DRAFT

**Specific Site Assessment for
Coal Combustion Waste
Impoundments at Duke Energy
Indiana (DEI) Gibson
Generating Station**

Owensville, Indiana

Figure 3

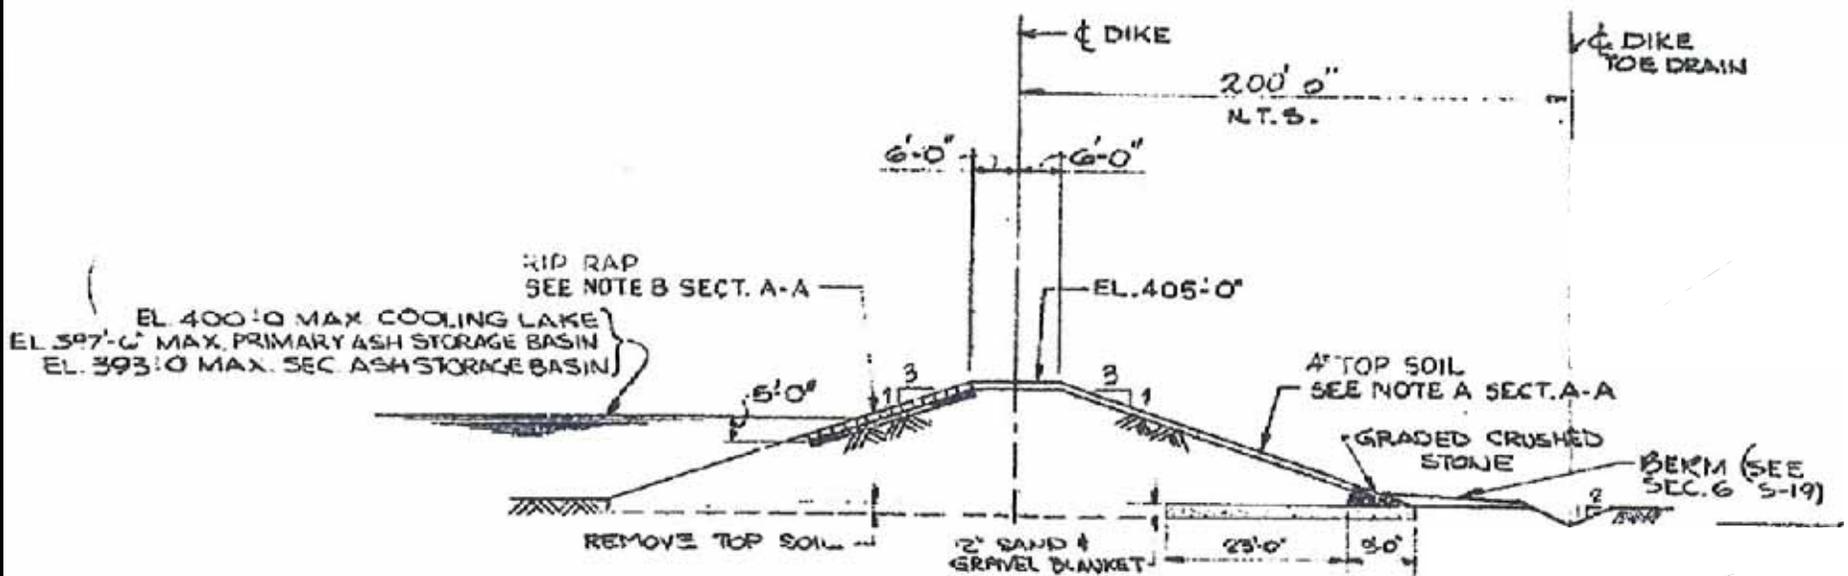
The dikes were constructed of homogeneous fill material, typically with riprap and/or geotextile armoring on the upstream slope to protect against wave erosion. Typical geometries of the dikes are shown in Table 2.1 and Figure 3. The southern dike for East Ash Pond #3 was constructed as a raise of the northern dike for East Ash Ponds #1 and #2. This was completed as a “downstream raise,” in which the raised East Ash Pond #3 embankment was constructed over the existing dikes and native ground. The raised embankment was not founded on the coal combustion waste contained in East Ash Ponds #1 and #2.
